DESIGN & ACCESS STATEMENT: ADDENDUM

Canalside,
Oxford North

On behalf of Hill Residential

2.0 Original Planning Approval Ref: 18/02065/OUTFUL

Figure 9. Block 6 & 7 Ground Floor Plan as proposed

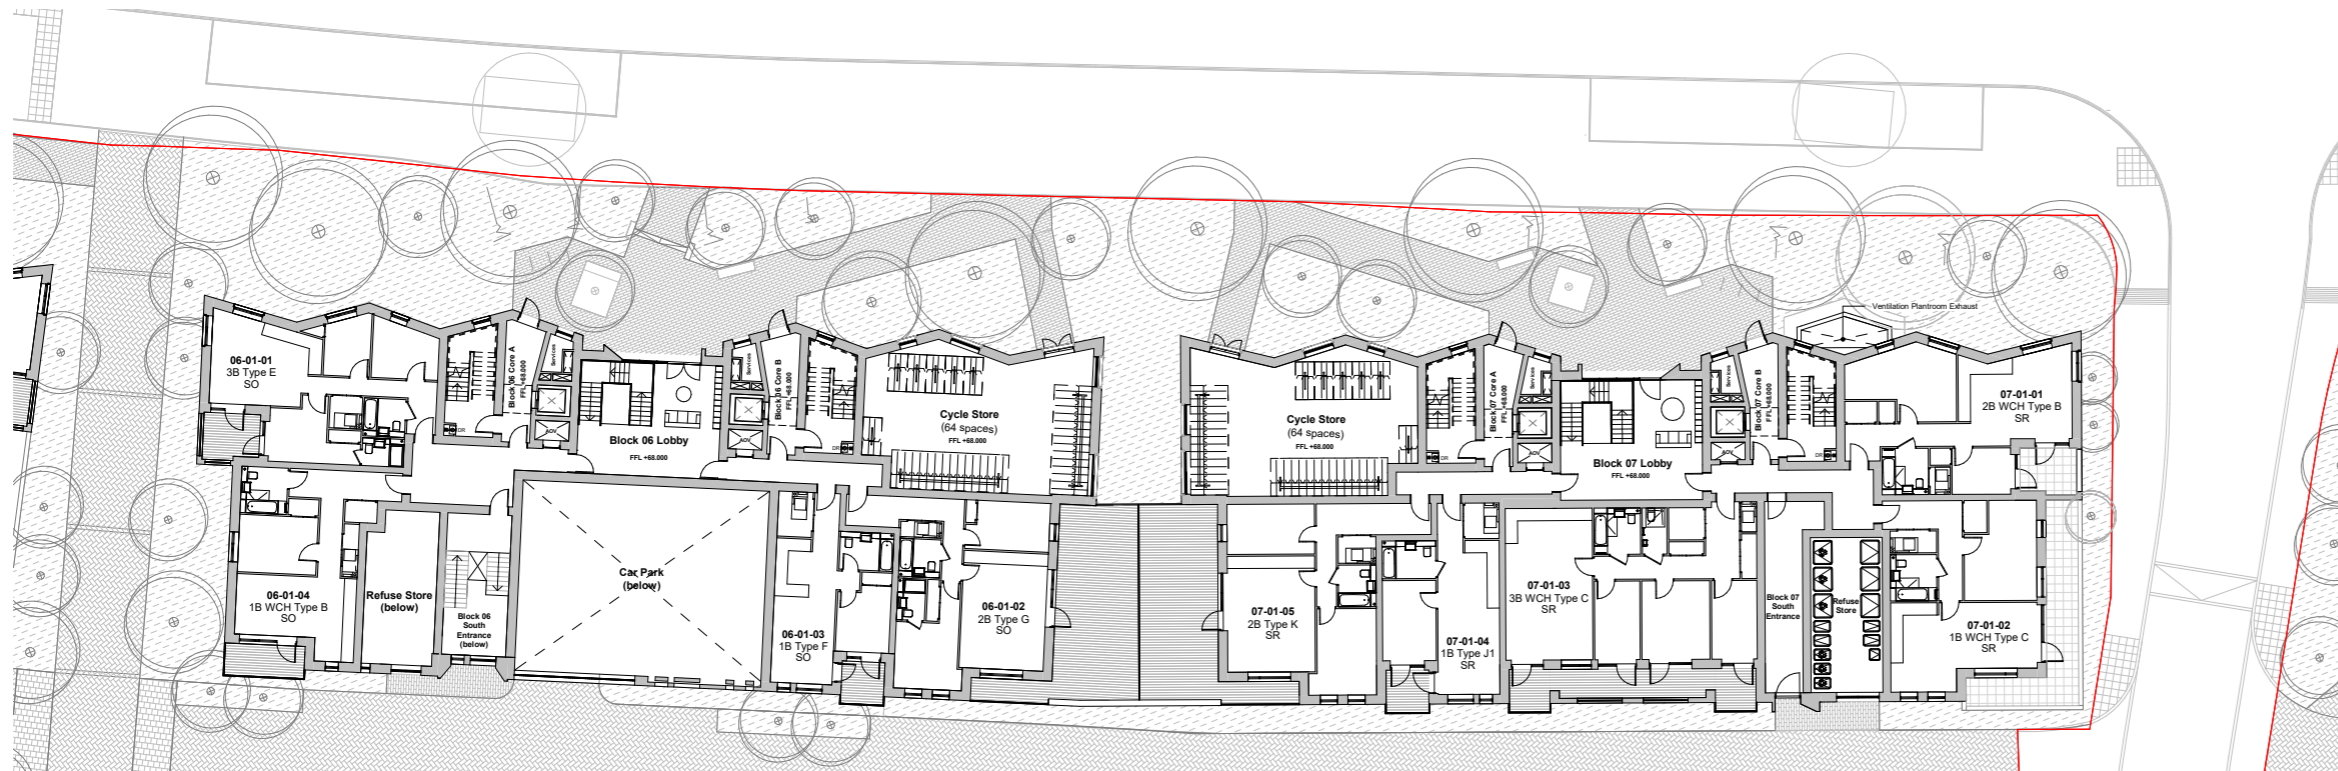
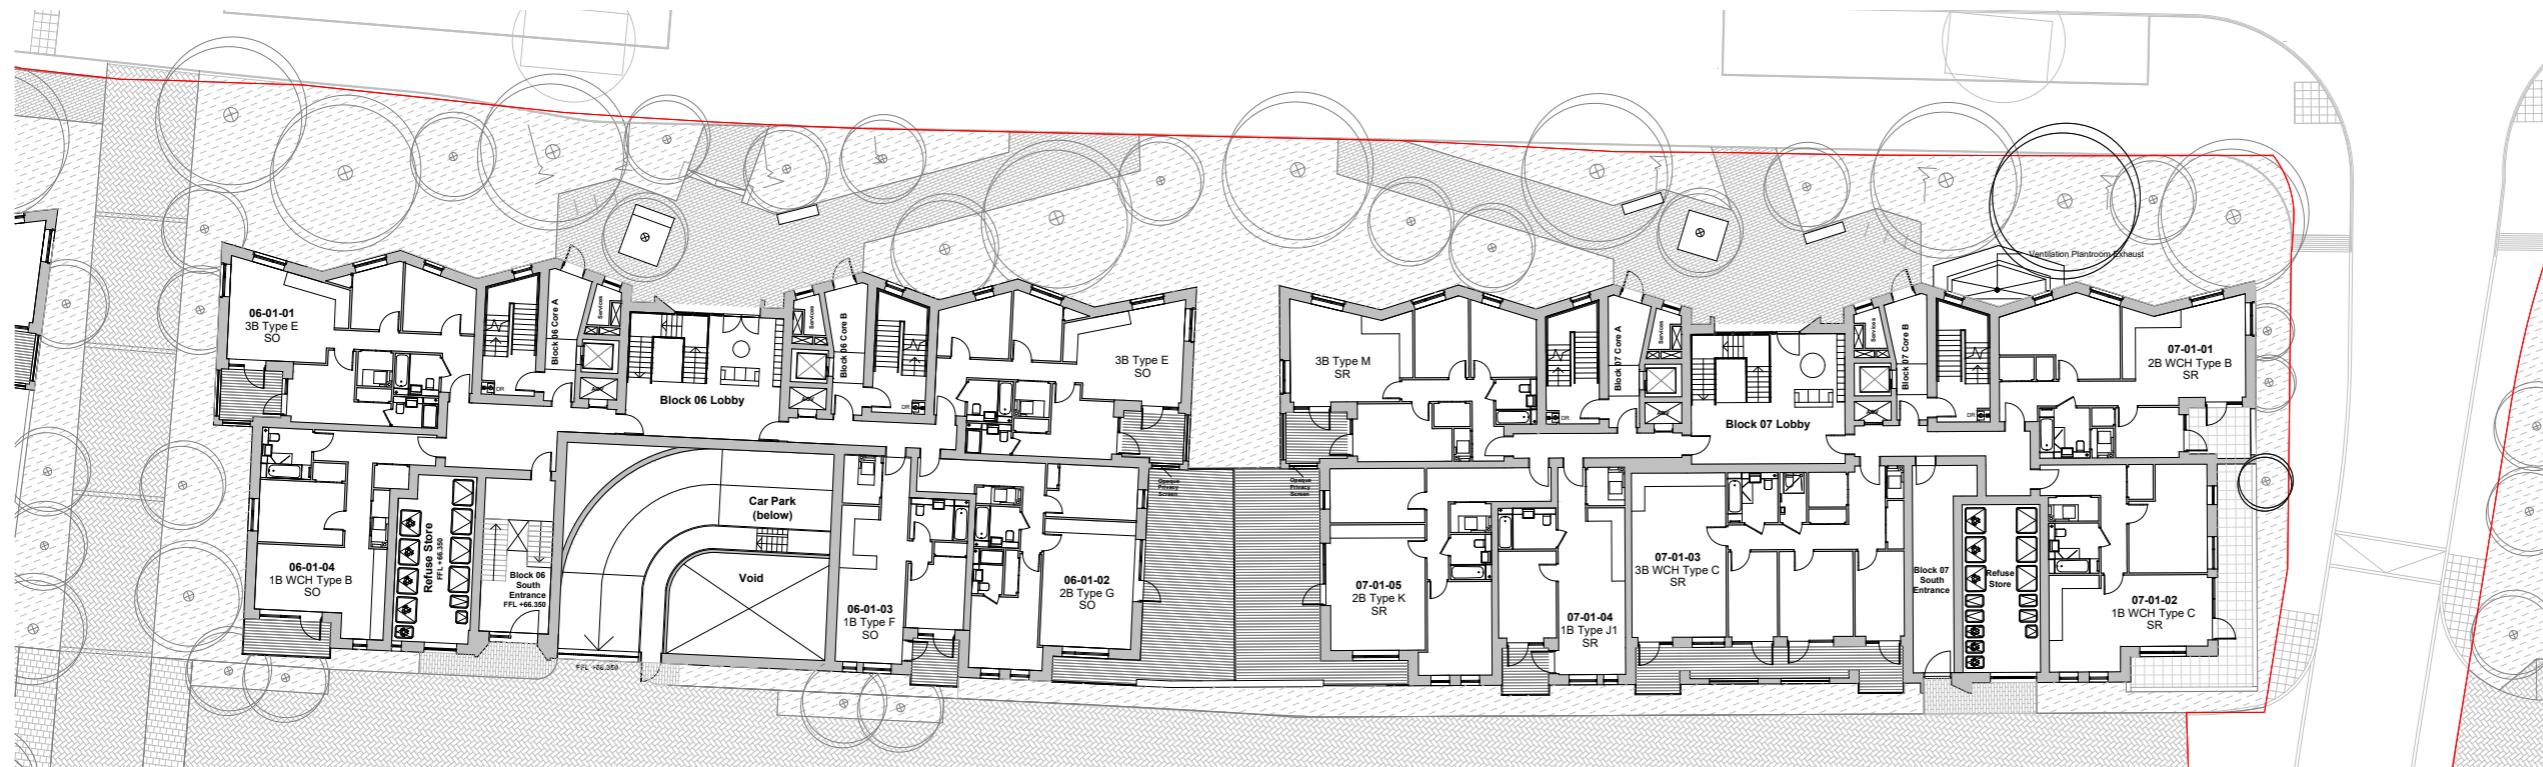
This application proposes the addition of two affordable 3-Bed flats.

The additional flats are proposed to be situated on the ground floor of Blocks 6 & 7, in an area originally proposed for cycle storage under the consented scheme.

The 2 additional flats can easily be accommodated within the ground floor of these blocks, with minimal changes to the layout and elevations of both blocks.

Figure 10. Block 6 & 7 Basement Floor Plan as proposed

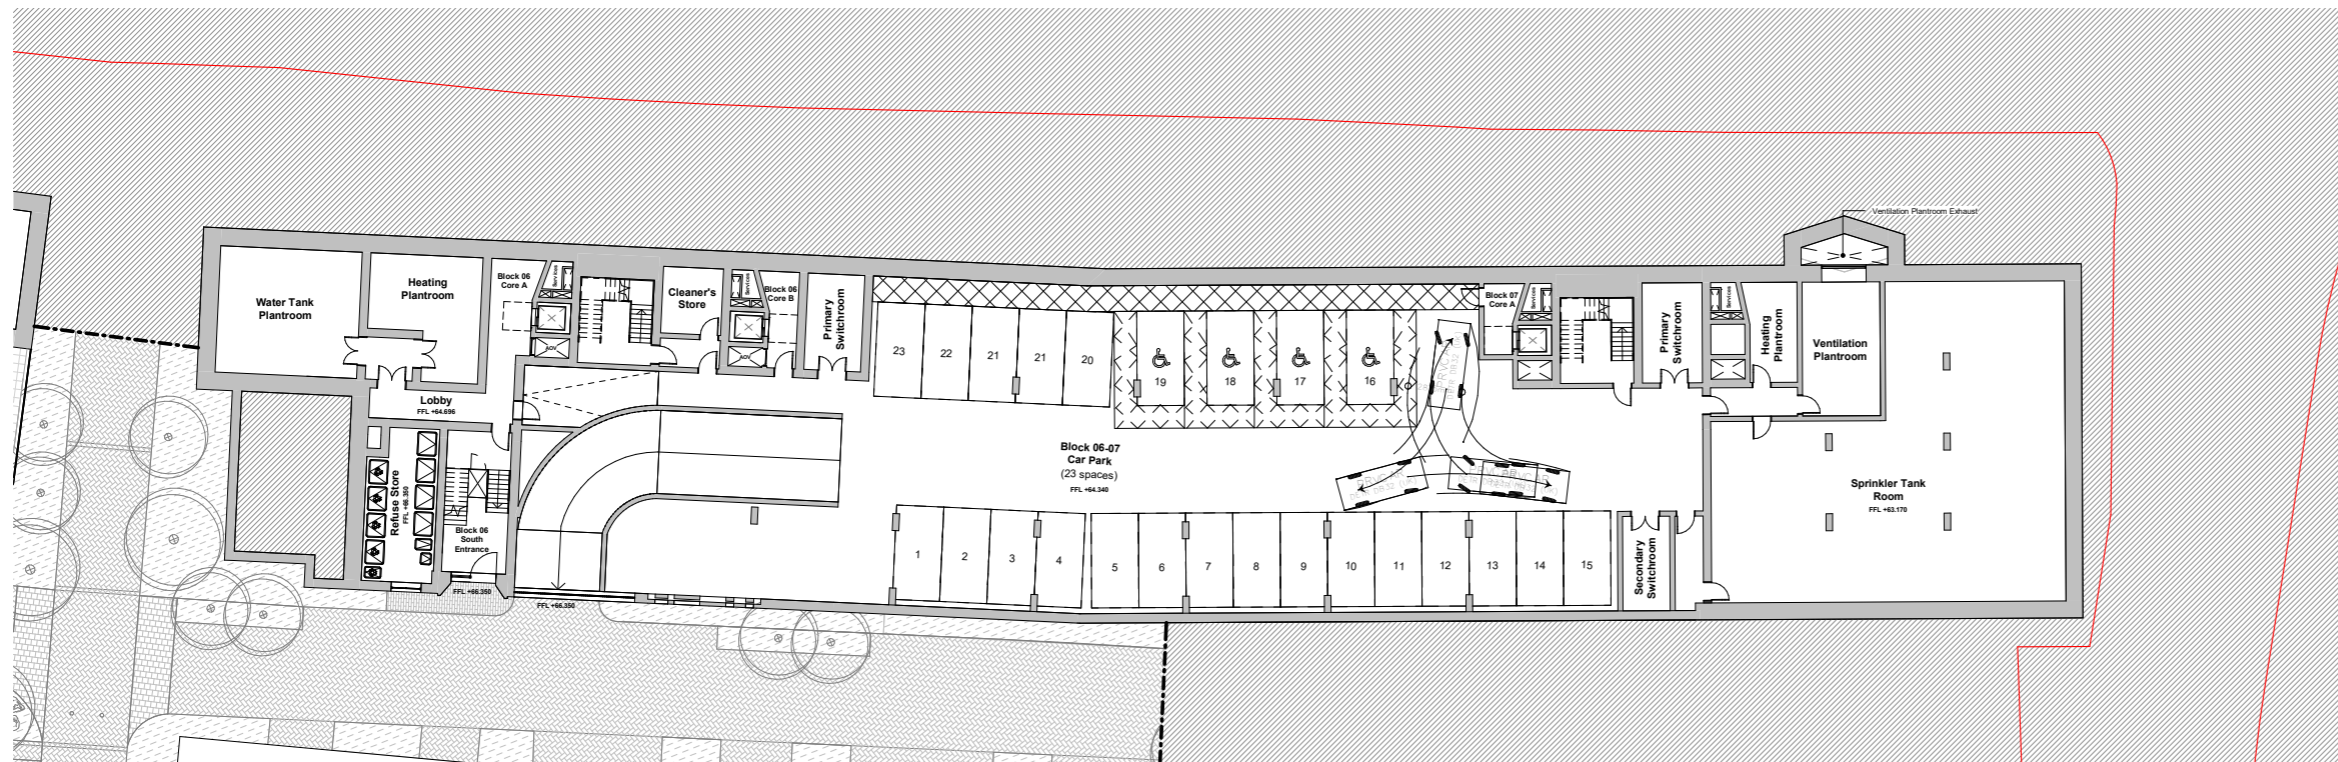
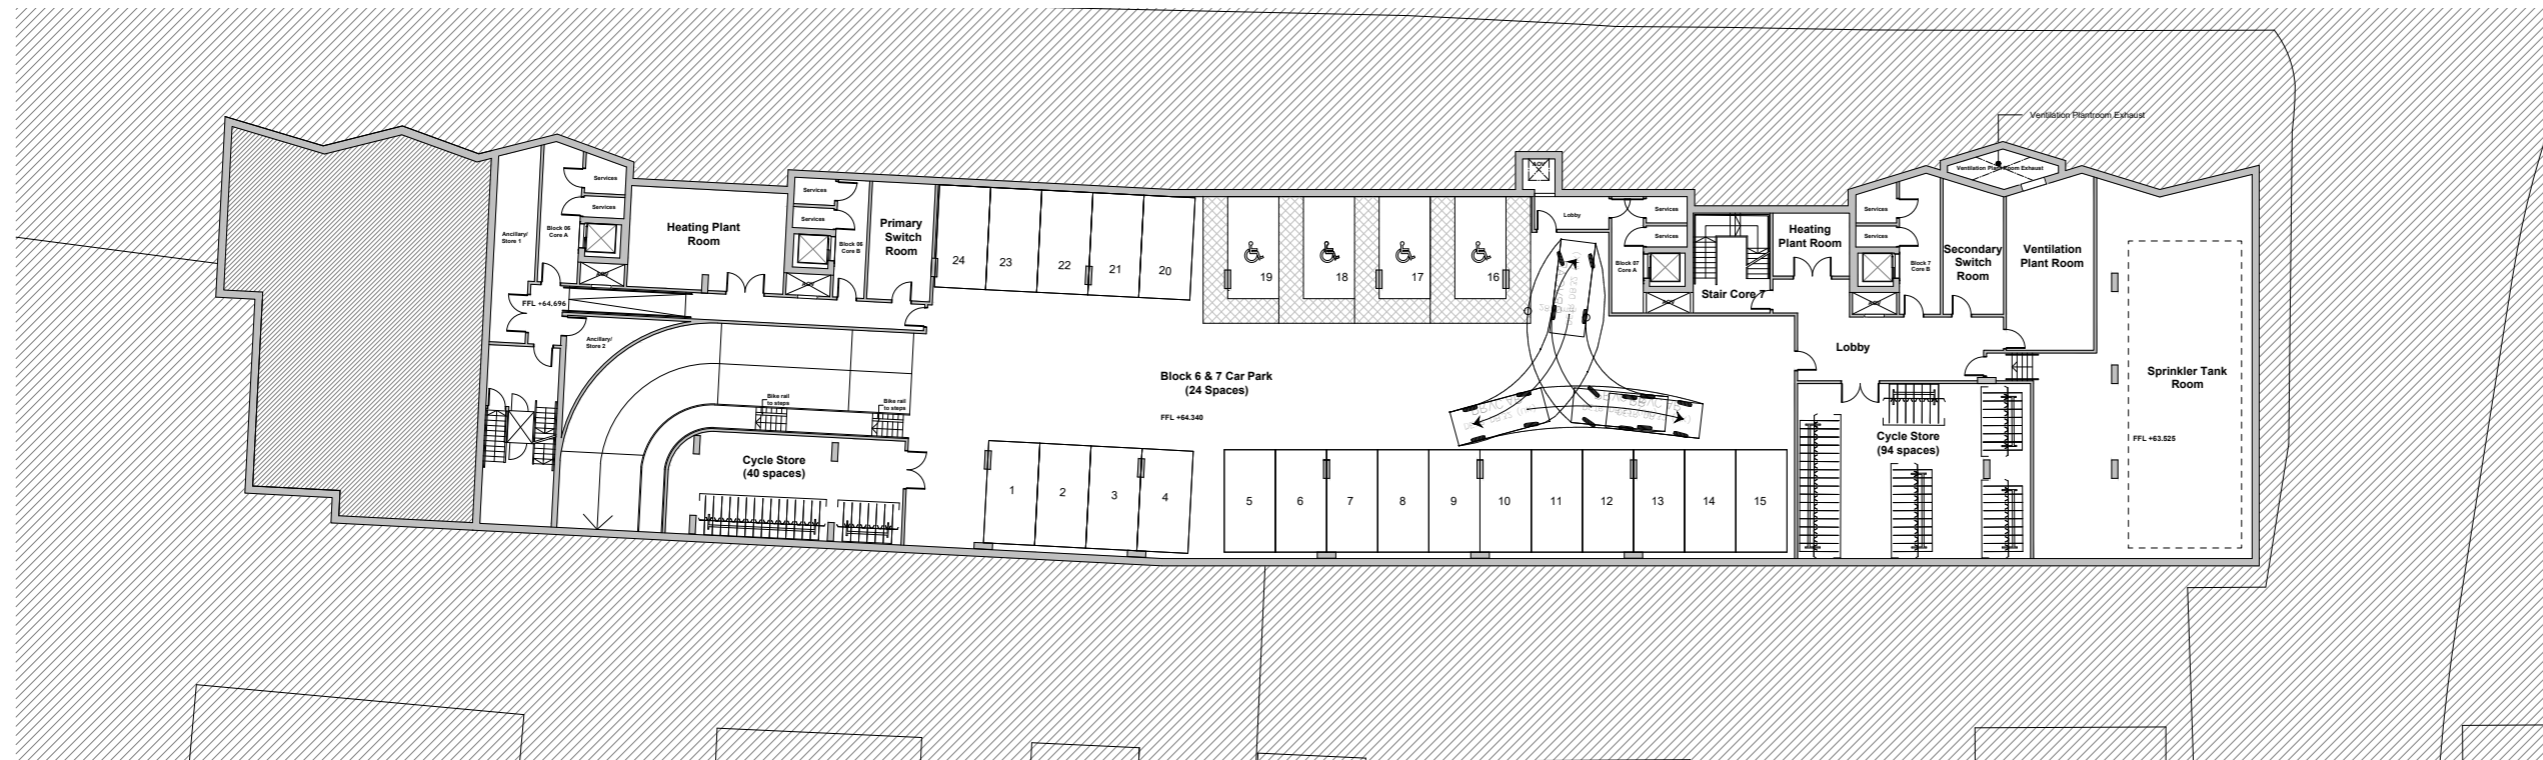
The bike storage is proposed to be relocated to the Basement of Blocks 6 & 7, in two separate dedicated bike stores. The first bike store is proposed to the side of the vehicular access ramp (in an area which was previously shown as void and was empty space). This bike store will provide space for 40 bikes. The second bike store is proposed to the South-eastern end of the basement in an area which was previously proposed as part of the sprinkler tank room (but was surplus to requirements, as the full extent of this space was not necessary). This bike store will provide space for 94 bike spaces.

Upon progressing with the project to Technical Design, it was realised that the size of space designated for the sprinkler tank room was far in excess of requirements. The changes proposed within this document will make for a more efficient use of space and provides two new affordable homes for Oxford, which are in demand.

The revised scheme relocates the bike storage to the basement level, with one store located to the side of the access ramp providing 40 spaces and a larger store located to the south-eastern end of the basement providing a further 94 spaces.

Figure 12. Block 6 & 7 South Elevation as proposed

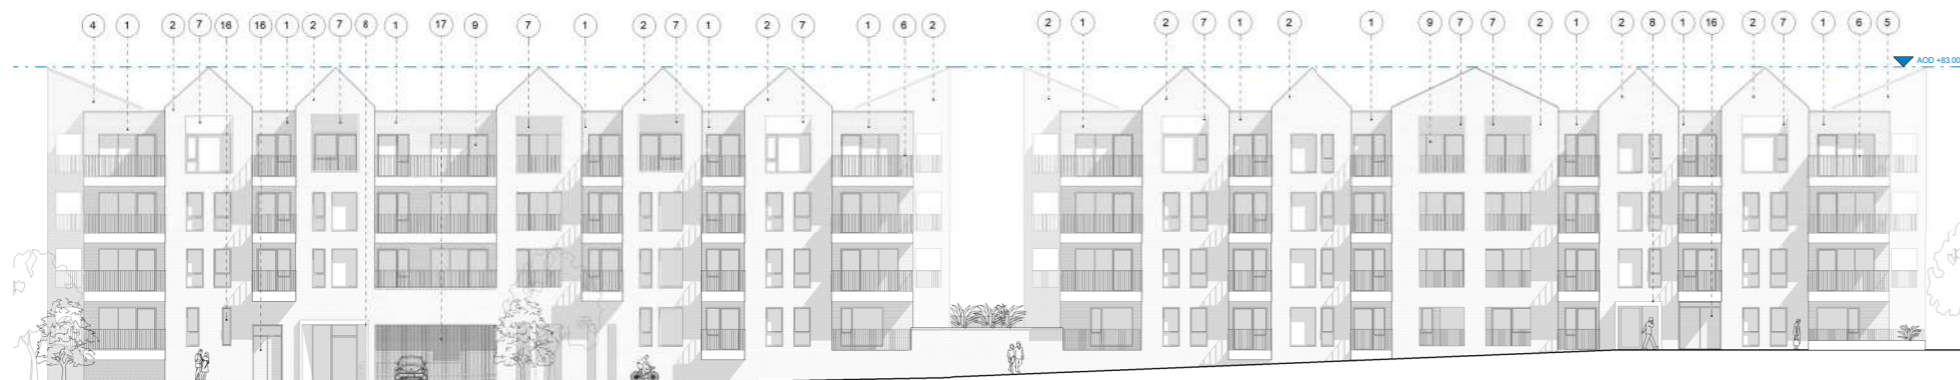
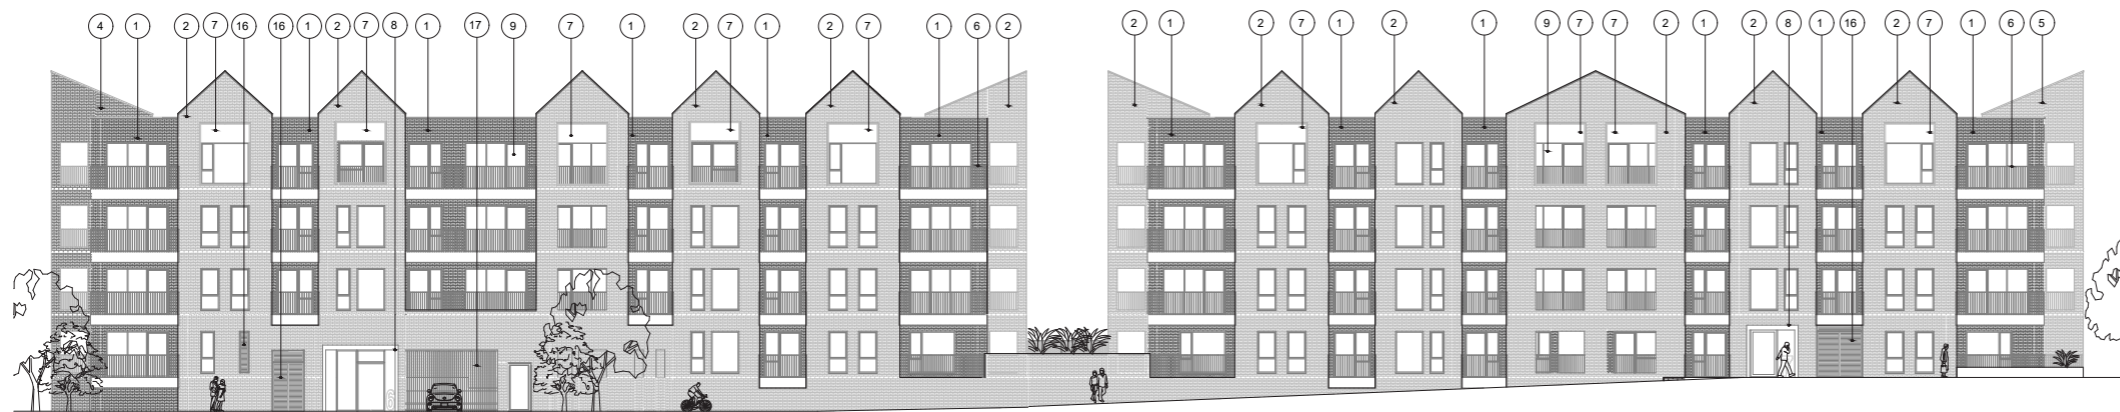
Both flats will 'stack' with the floor above to create consistent and aligned elevations.

Figure 18. Proposed Bike Store 1. (40 spaces).

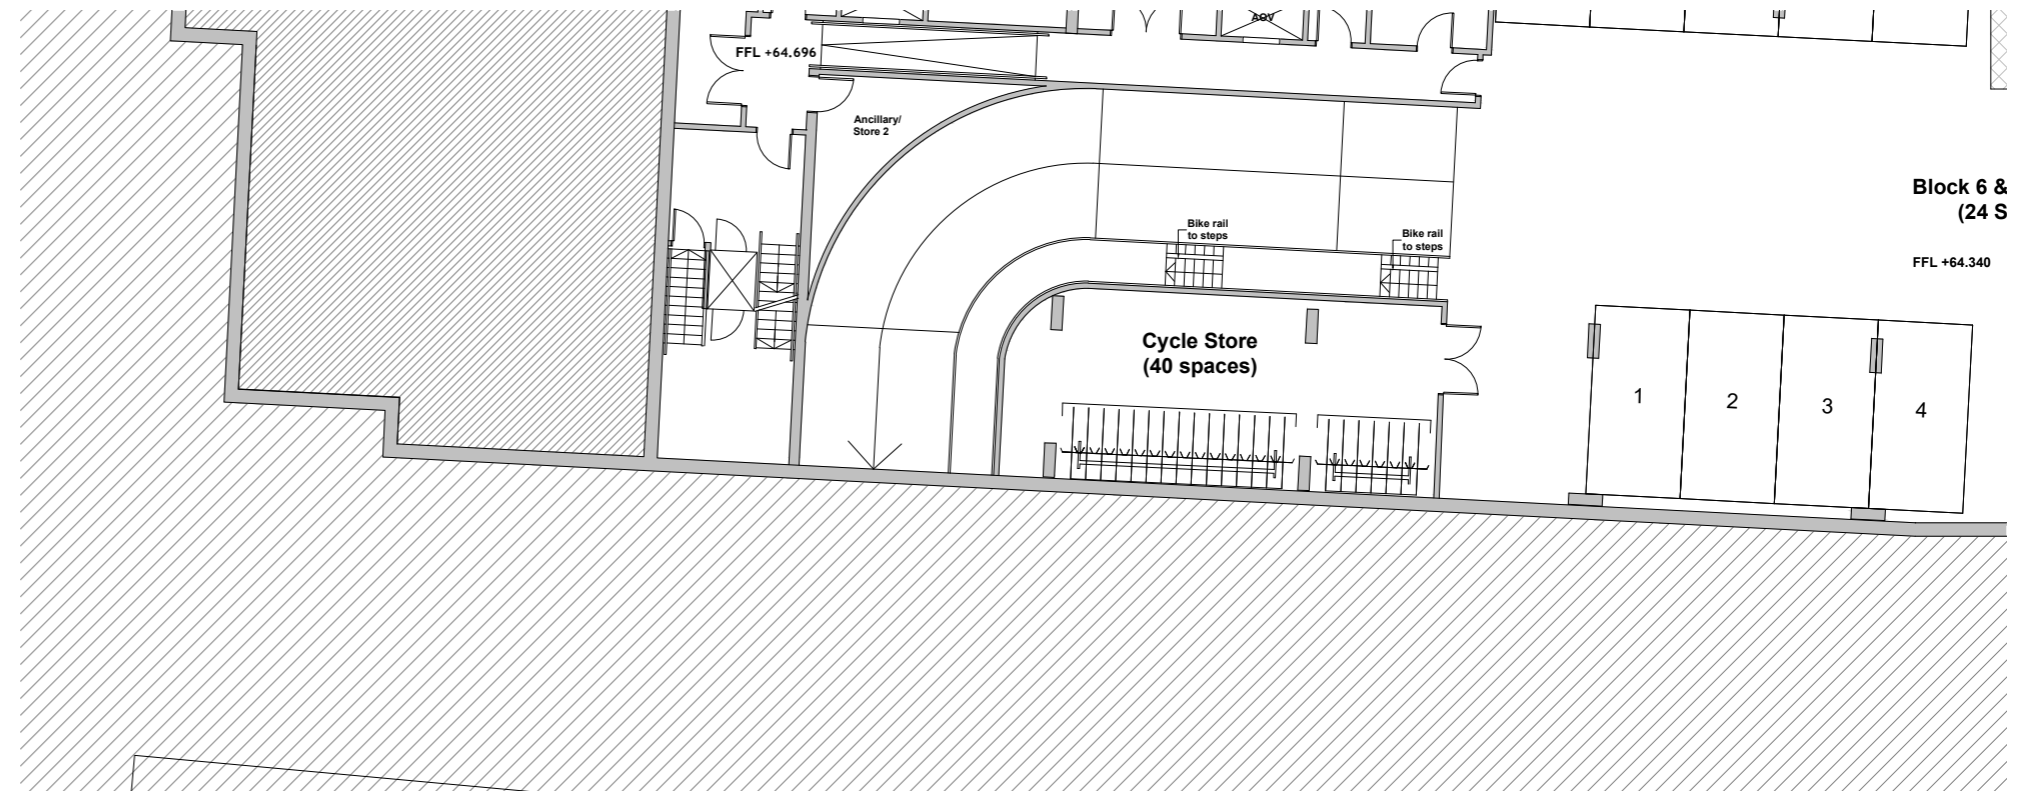
A bike rail ramp has been proposed to the side of the pedestrian access, alongside the vehicular ramp to allow bikes to be transferred to and from the basement safely.
